#### ADDENDUM #2

## Will County Health Department BID PACKAGE #3 – MEP/Finishes/Carpentry/Glazing December 4, 2018

#### SECTION 00 91 08 BP #3 - ADDENDUM NUMBER 2

PROJECT: WILL COUNTY HEALTH DEPARTMENT - NEW HEALTH DEPARTMENT

SITE TELECOMMUNICATION PLAN - EXISTING

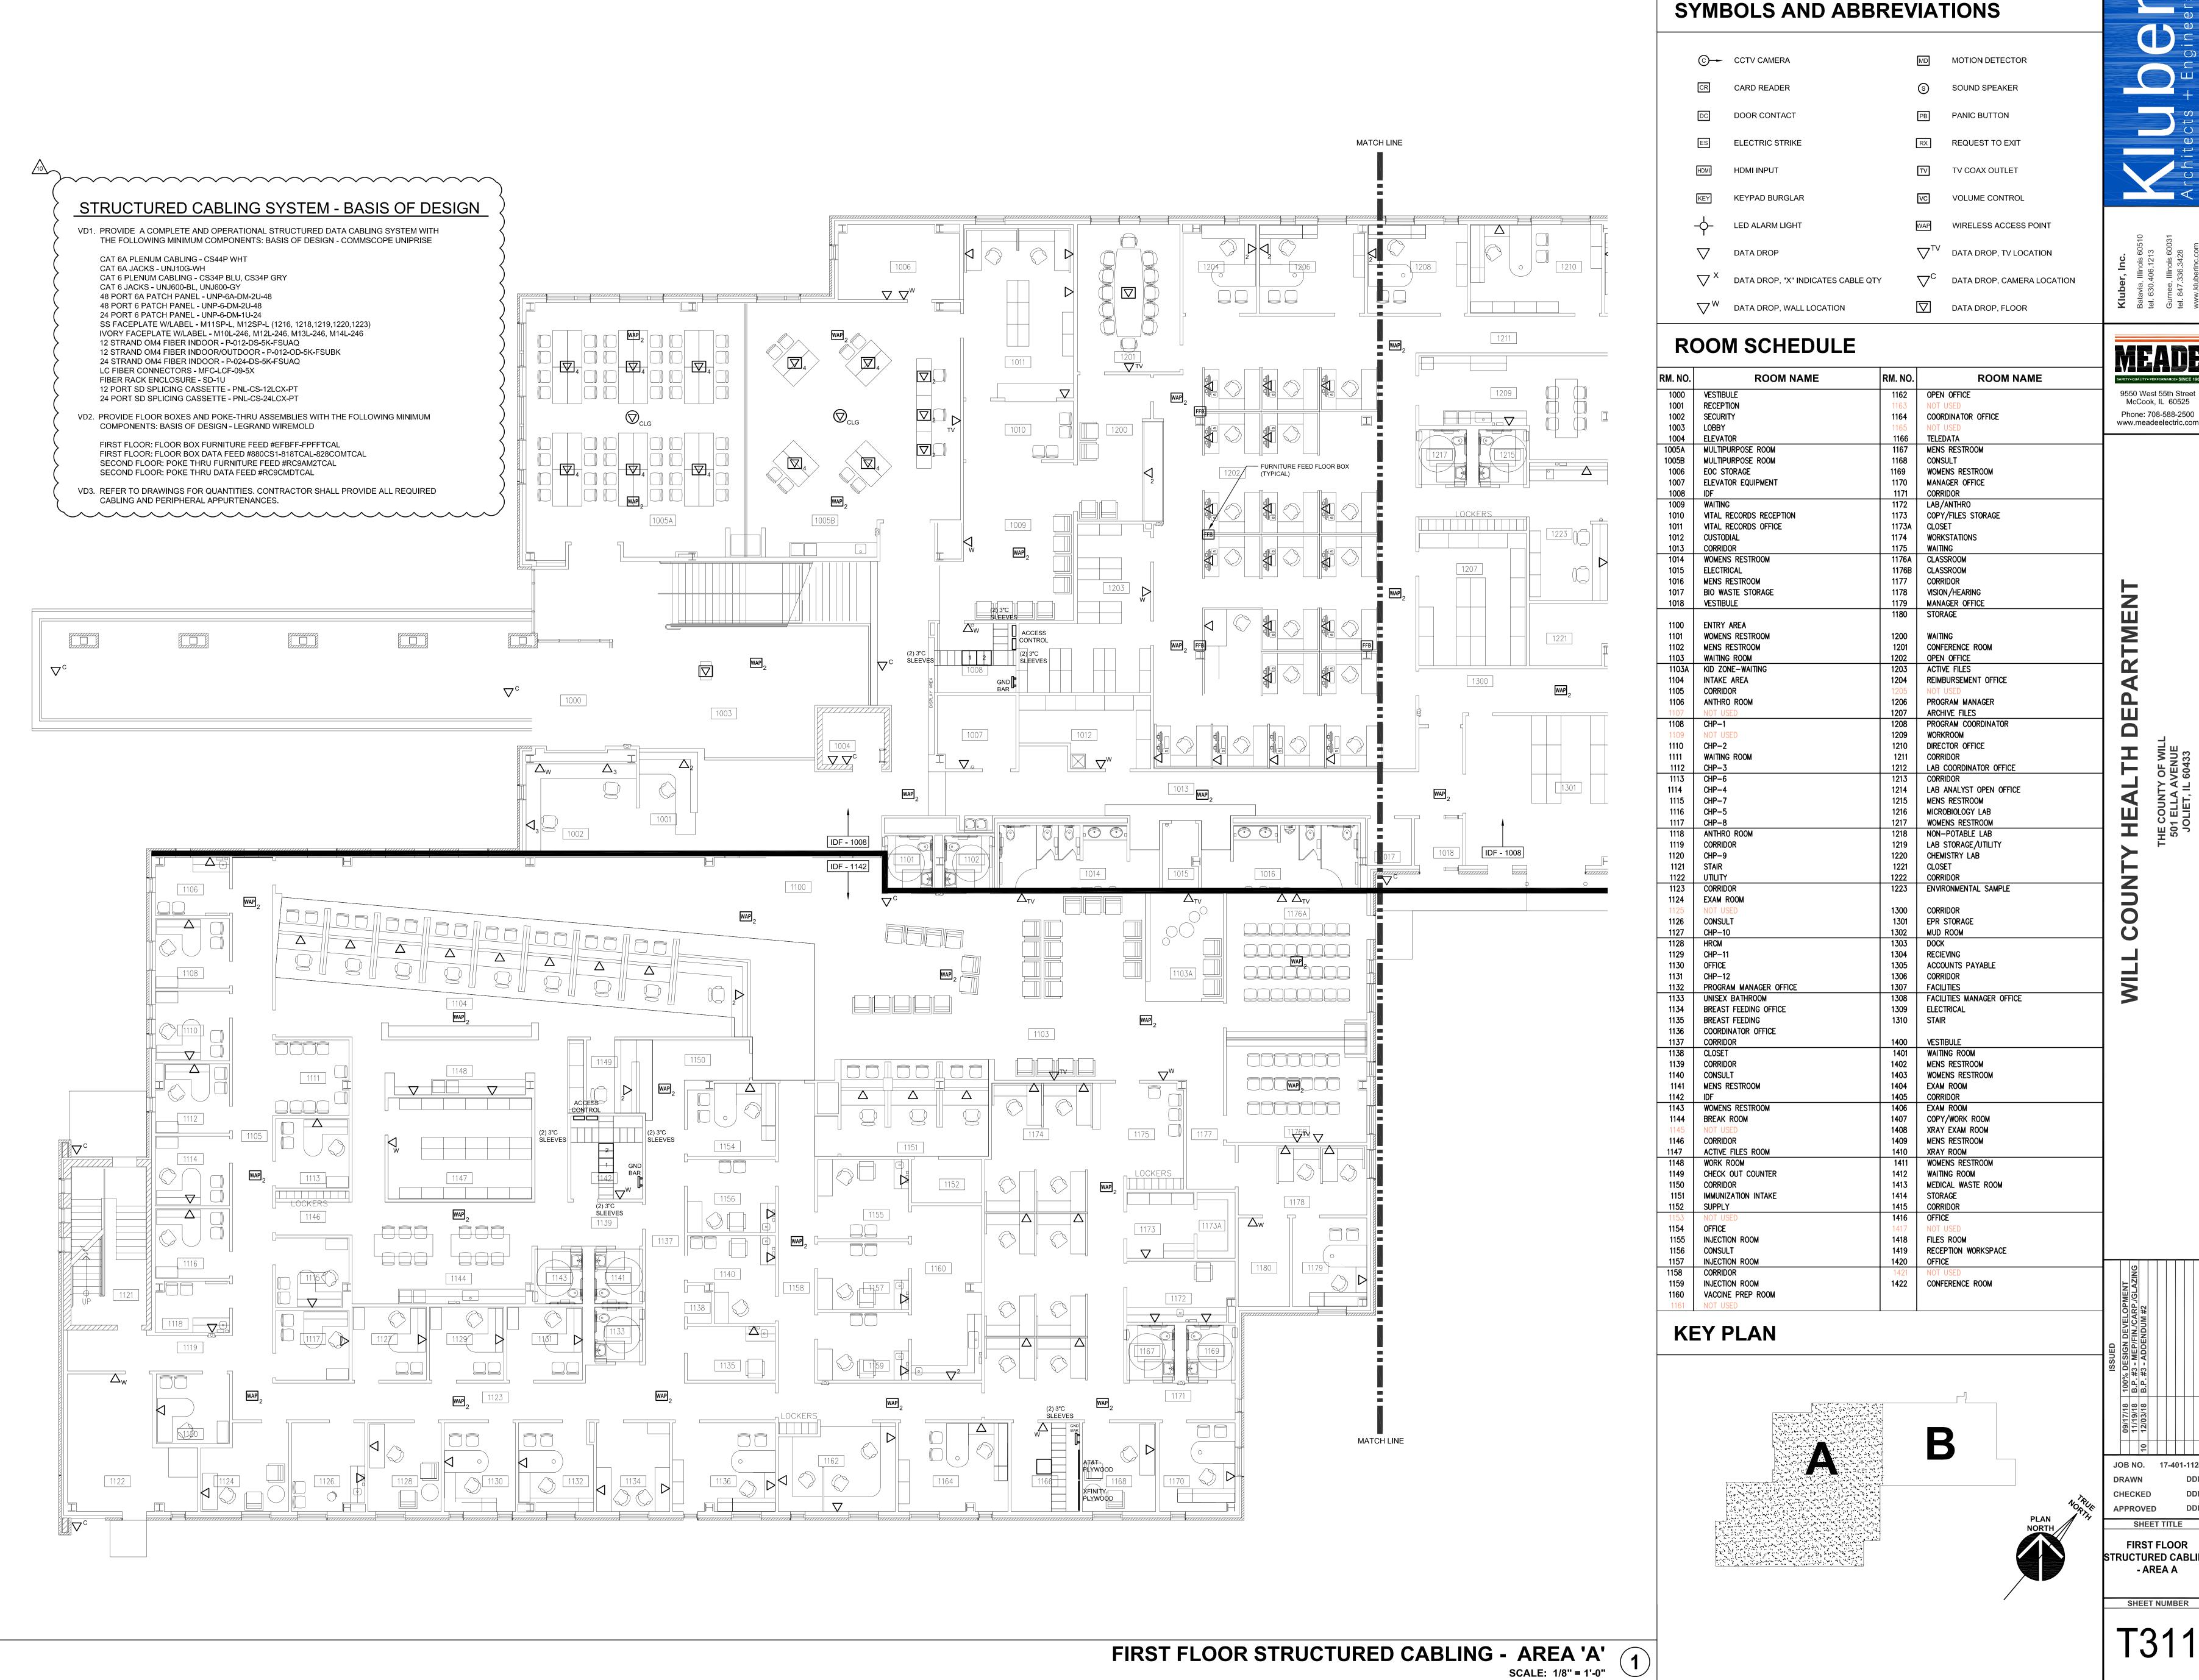
A. (For contractor clarification only): Clarified and corrected written text at the right hand side of the page that was corrupted during printing for reference and clarification. See revision cloud 10.

T001

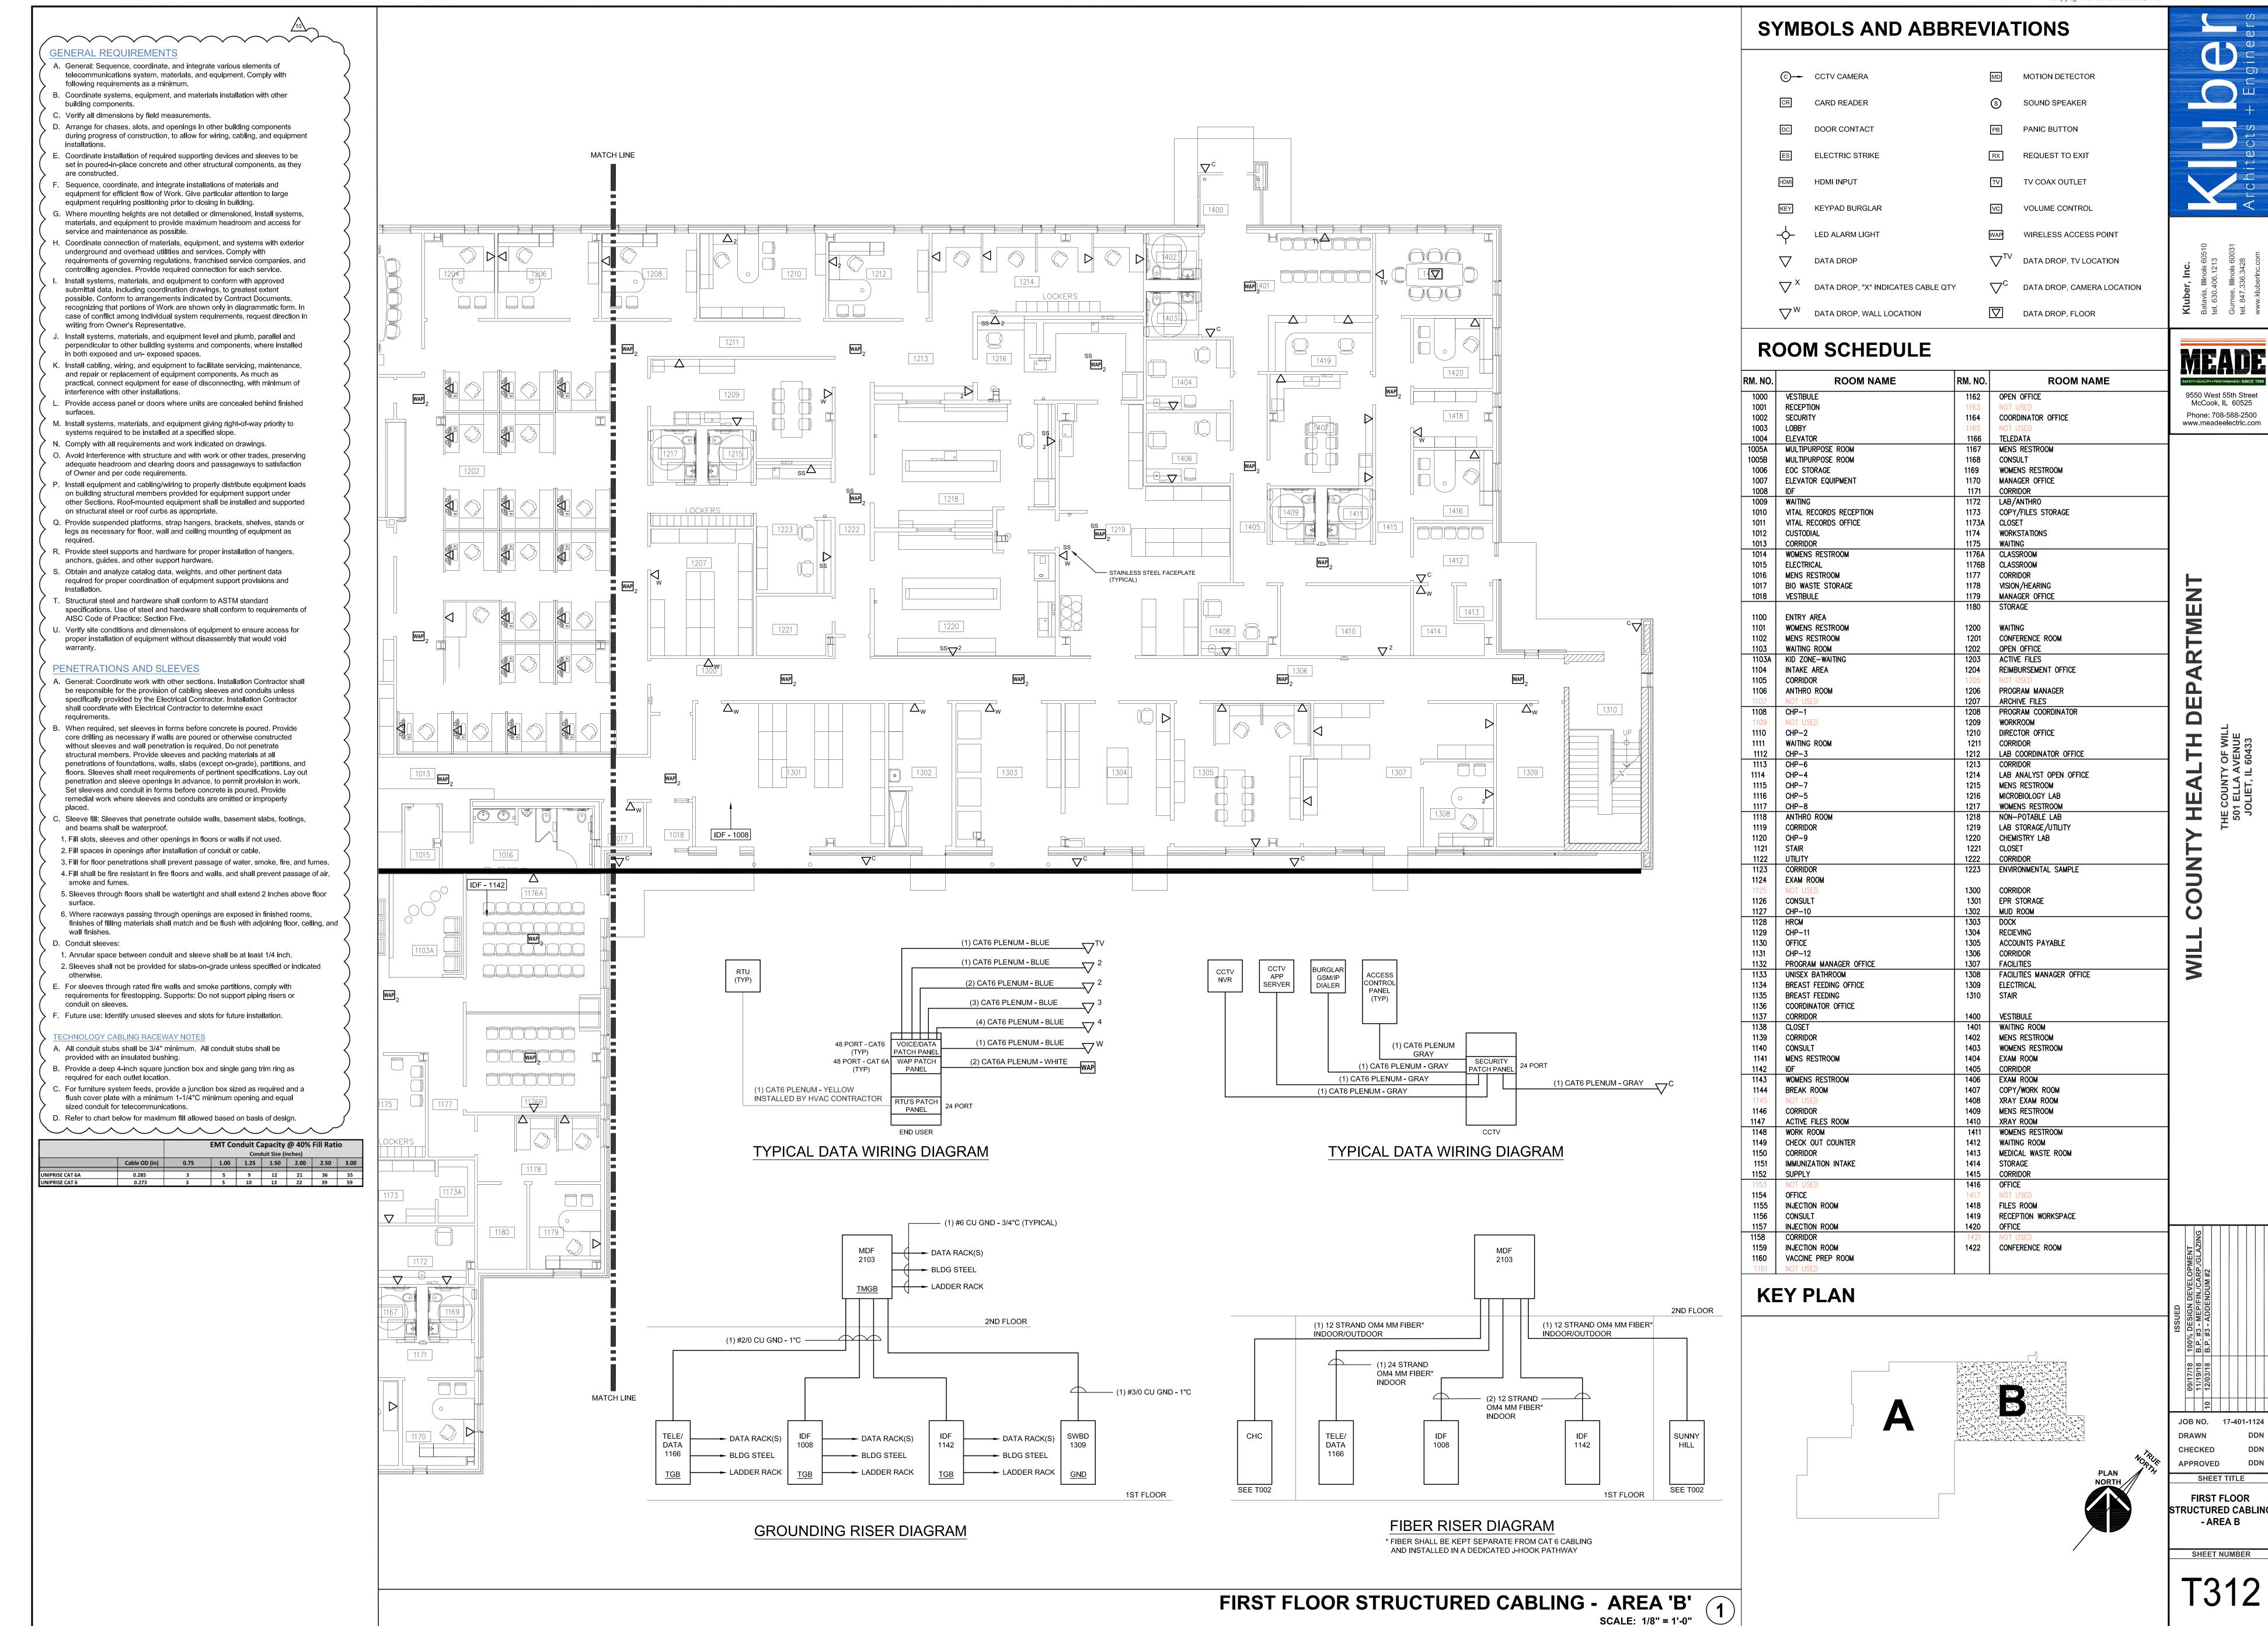
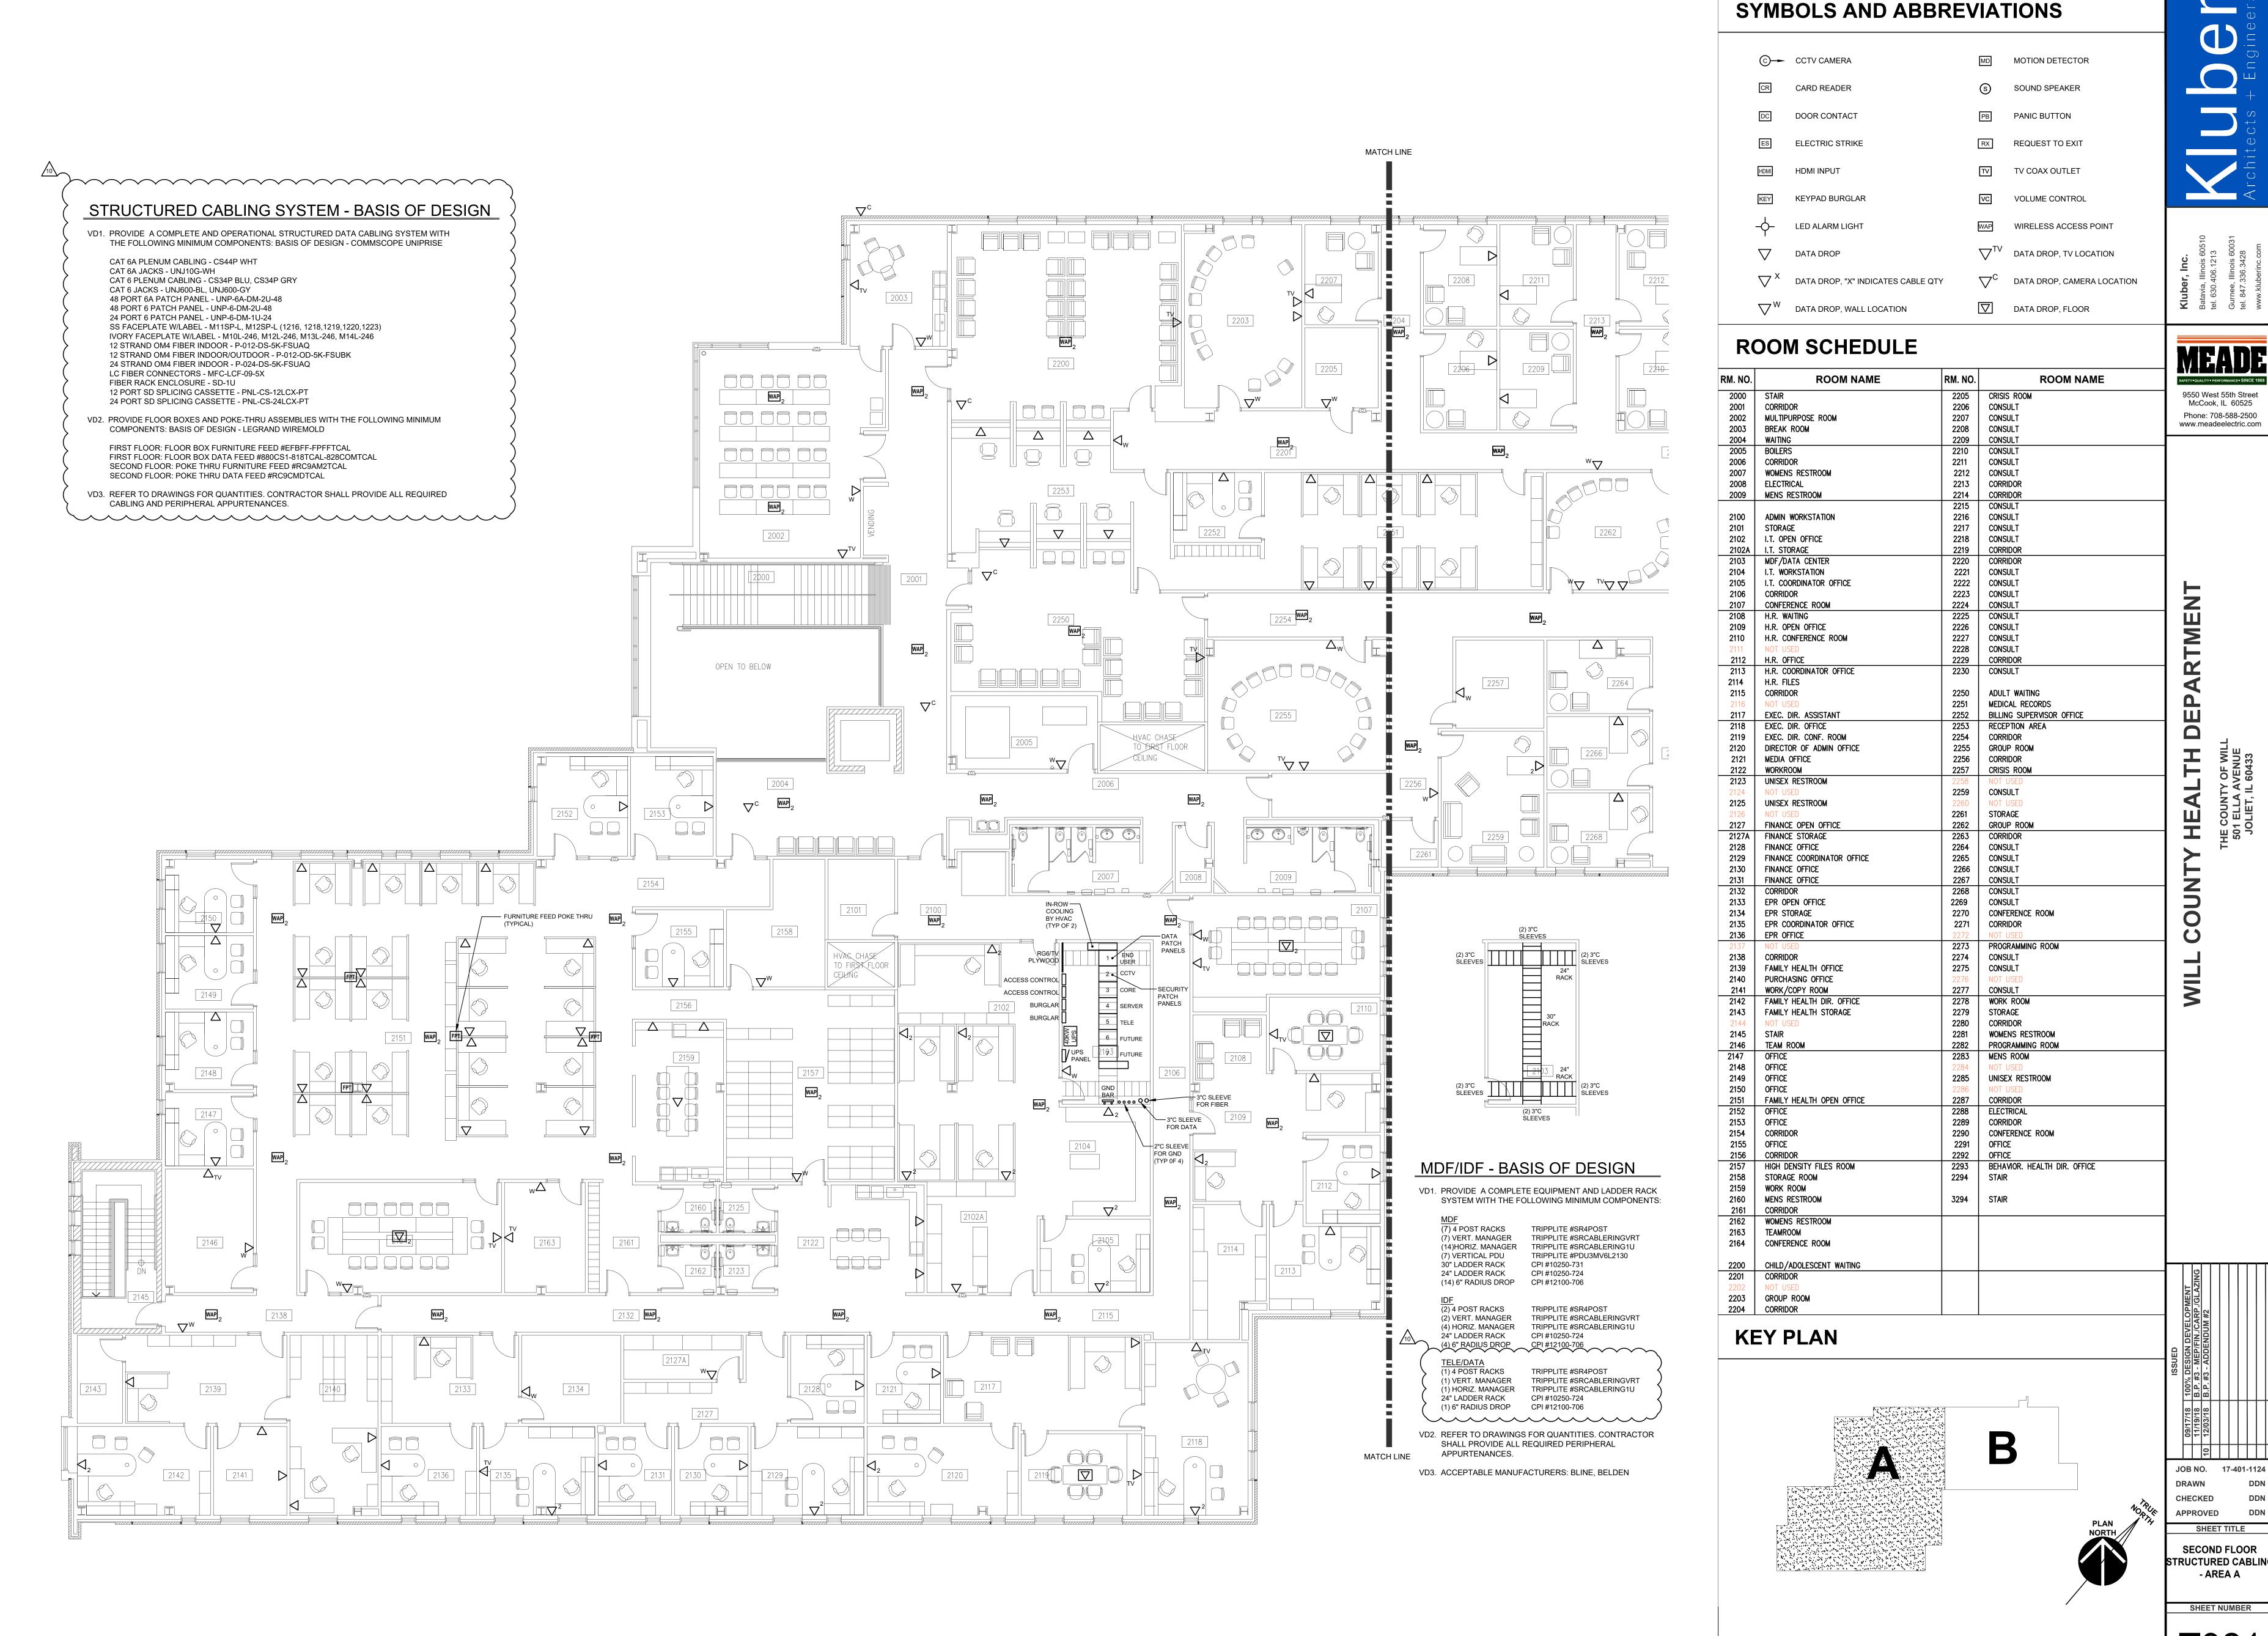
A. (For contractor clarification only): Clarified and corrected written text at the right hand side of the page that was corrupted during printing for reference and clarification. See revision cloud 10.
